URBAN DESIGN COMMITTEE

URBAN DESIGN COMMITTEE STAFF REPORT

APPLICATION NUMBER	Urban Design Record #23096
APPLICATION TYPE	Advisory Review
ADDRESS/LOCATION	1434 O Street
HEARING DATE	August 01, 2023
ADDITIONAL MEETINGS	-
APPLICANT	Omar Attaie, pitaandnaan@gmail.com
STAFF CONTACT	Arvind Gopalakrishnan, 402-441-6361, agopalakrishnan@lincoln.ne.gov

UDR23096 - Pita & Naan Sidewalk Café (1434 O Street)

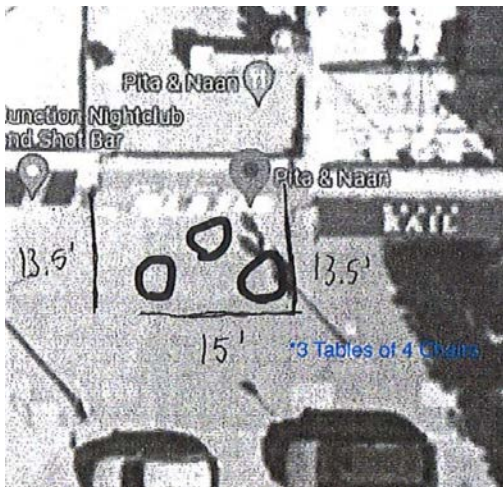
The sidewalk space available outside of the building is approximately 24' wide. Installing a 13.5' wide fencing would leave around 10.5' of passageway for pedestrian movement spanning the length of the building fronting O Street. However, currently there is a streetlight on one of the corners of the proposed side walk café, and it is situated in the passageway (space between the edge of the proposed fencing and the curb). This edge of the sidewalk café railing might interfere with the pedestrian and bike traffic and make part of the passageway congested. The hand-drawing below was included by the applicant in the application package, and the two following images are a diagrammatic representation of the same.

Initial Concept with the sidewalk café attached to the restaurant. (Received from the applicant)

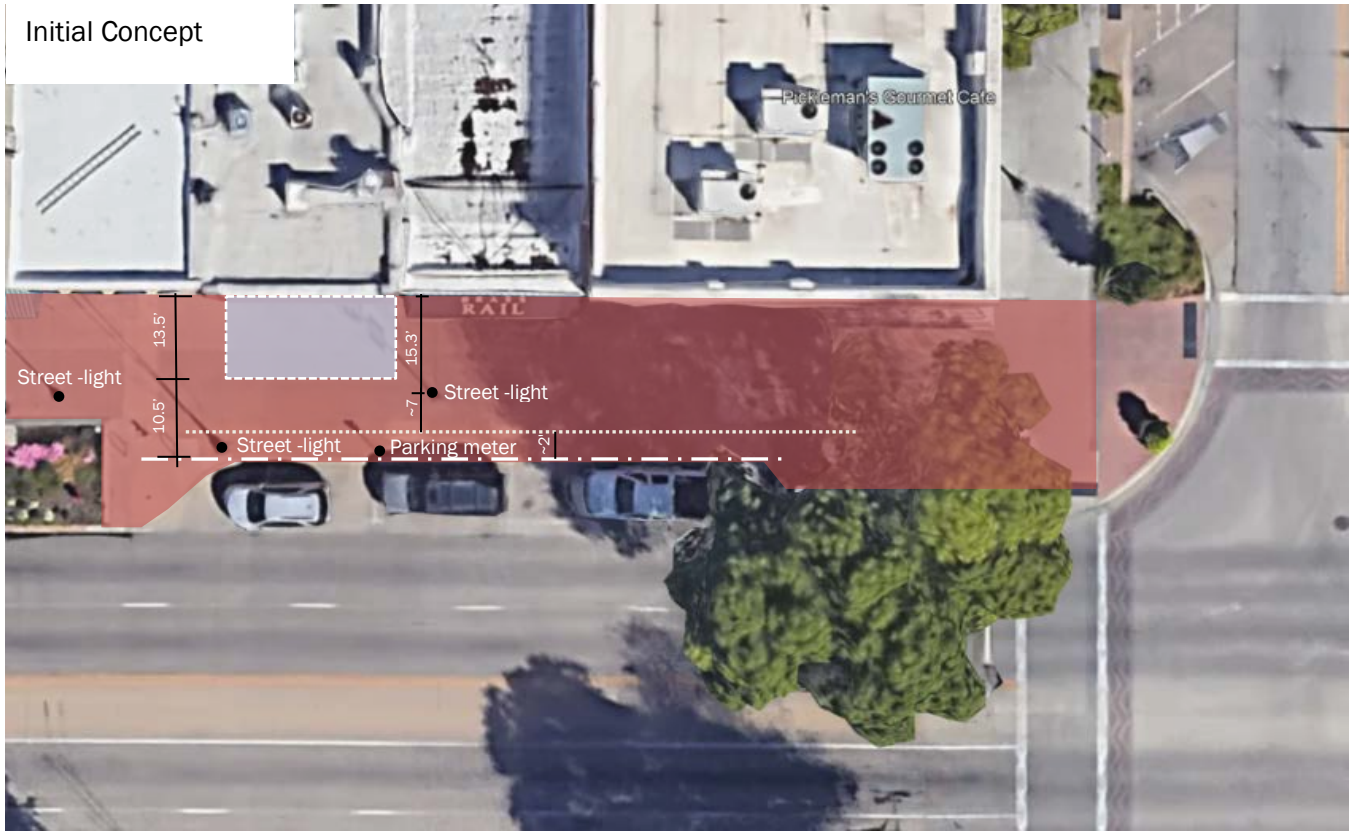
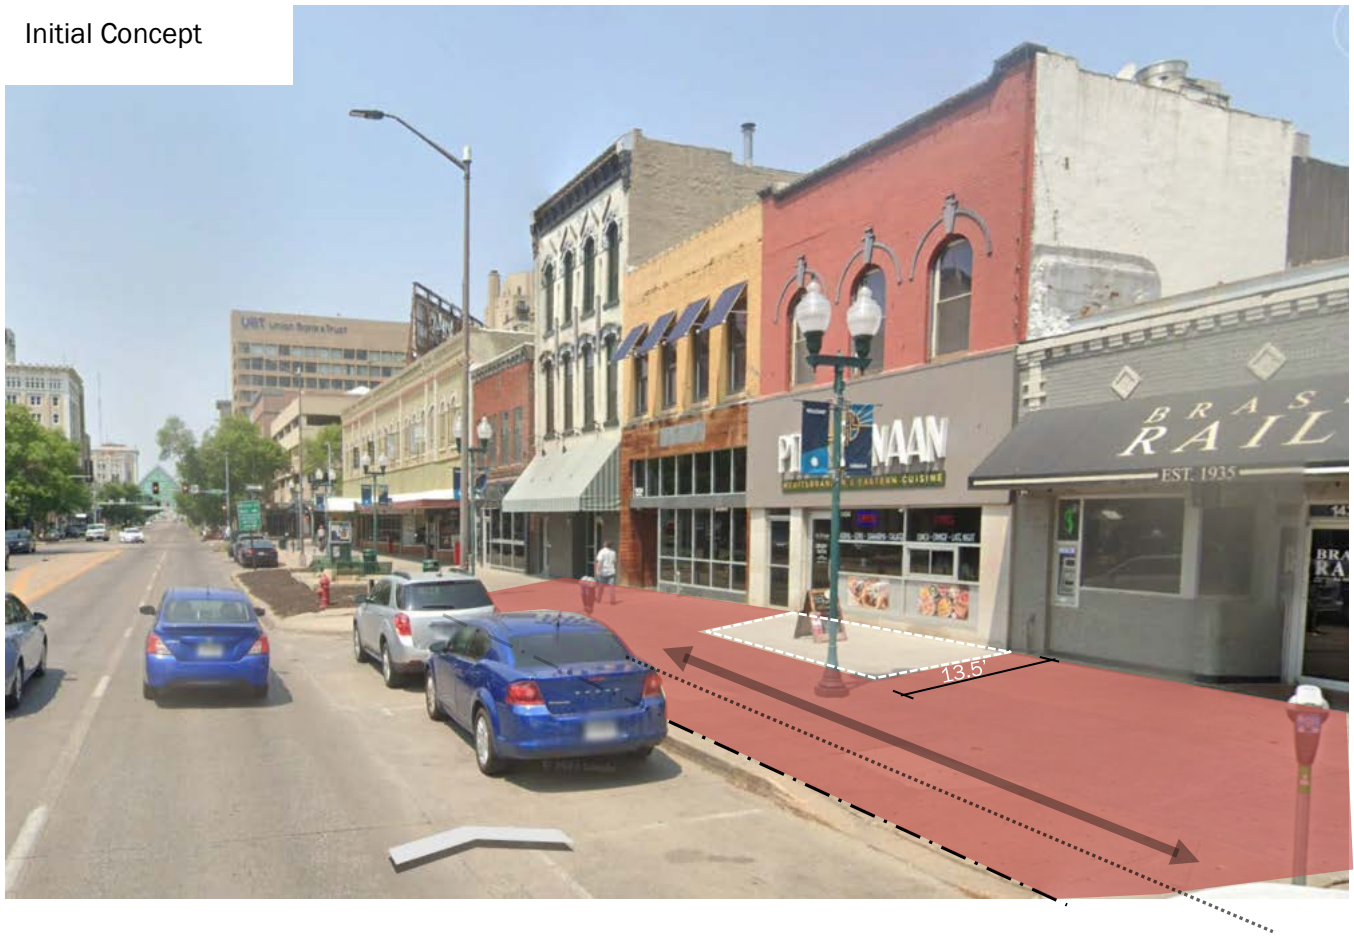
The hand-drawn sketch of the potential fenced space provided by the applicant does not address the available obstructed or unobstructed passageway after considering a 13.5' wide sidewalk café. A drawing showing the exact dimensions of the sidewalk café space and the resultant pedestrian passageway is essential to make a decision on the application.

After careful consideration, staff recommends that the sidewalk café be 11' (maximum 12') wide, leaving about 3'6" of pedestrian passageway between the café fencing and the light pole, and about 7' between the light pole and the curb. Extending the café space closer to the pole would conflict with the requirement for an unobstructed passageway of 6'. Thus, the maximum recommended dimensions of the sidewalk café are 12'x20' with a 5' open entrance exactly in front of the main door.

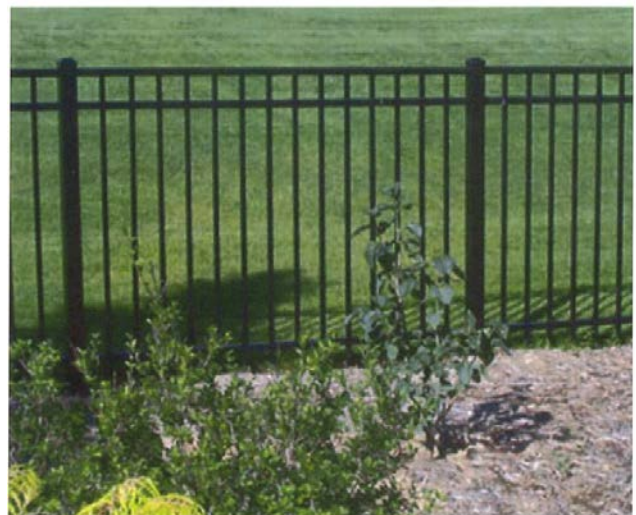
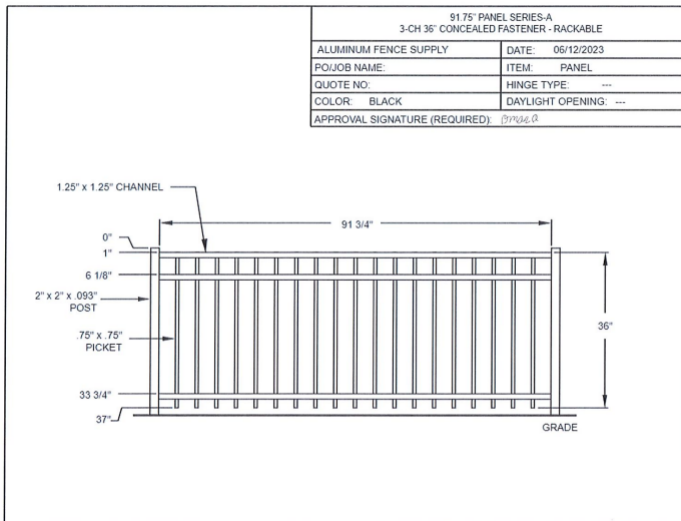
- As per the initial sketch submitted in the application, the permit area would be separated from the pedestrian passageway with a metal railing.
- Height: 36 inches – compliant
- Railing clearance not more than 27" – compliant
- Capacity: 12 persons – compliant
- The restaurant plans on serving alcohol, and hence, the entrance on the side fronting the restaurant shall not exceed 8', and the café area has to be attached to the restaurant.

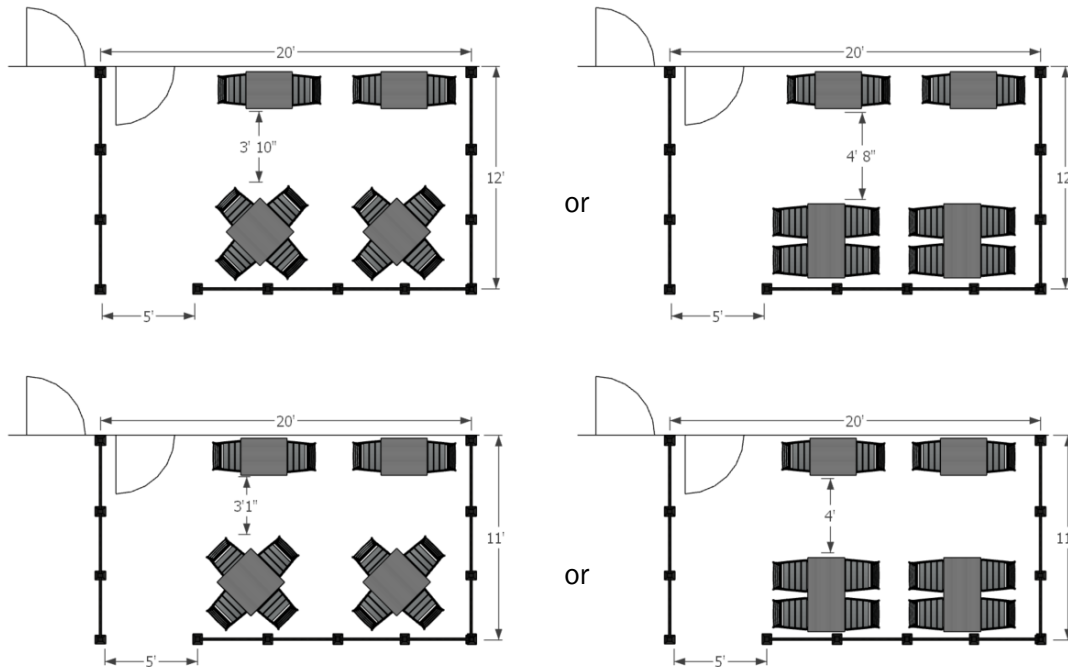
- Choice of furniture included in the application. 3 sets of 4-seaters

- Dimensions of the outdoor table, and the arm chairs are not included in the application.

In order to meet ADA clear zones, staff recommends:

30" x 30" square tables (4 seater: diagonally placed) or

24"x 48" tables (4 seater: parallel to the restaurant façade)

24" x 30" tables (2 seater: parallel to the restaurant façade)
